#### Subject: R21BB - FMVSS 210 Noncompliance: Installation of Seats with 3-Point Belts with Floor Tracks

#### IMPORTANT SAFETY RECALL NOTICE NHTSA Campaign Number: 21V-070 (School Bus)

# **R21BB – Installation of Floor Tracks with 3-Point Seats**

Illustration 1

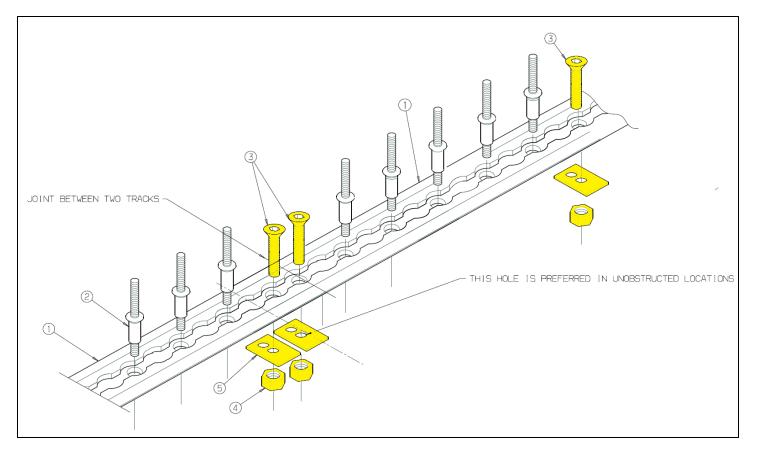
Issue: On some affected buses, fasteners used to secure the floor track may be missing reinforcement plates, resulting in a non-compliance with FMVSS 210, Seat Belt Assembly Anchorages

Locate the beginning and ending point of the floor track. Located within 1" of the ends of the floor track (item 1) will be capscrews (item 3). From the underside of the unit, inspect for installation of reinforcement plate (item 5), reference illustration 1.

NOTE: Capscrews, nuts and plates are installed within 1" from each end of the track or at a track joint. Magnabulb rivets (item 2) are installed on 2" centers in all other positions

- 1. At each end of the floor track (item 1), locate and remove the existing allen head screw (item 3) and nut (item 4). These may be discarded
- 2. Install new allen screw (item 3), plate (item 5), and nut (item 4) per illustration 1 and torqued to 8-10 FT LBS

NOTE: When capscrew location falls out on top of an auxiliary crossmember use 4" capscrew 01666106
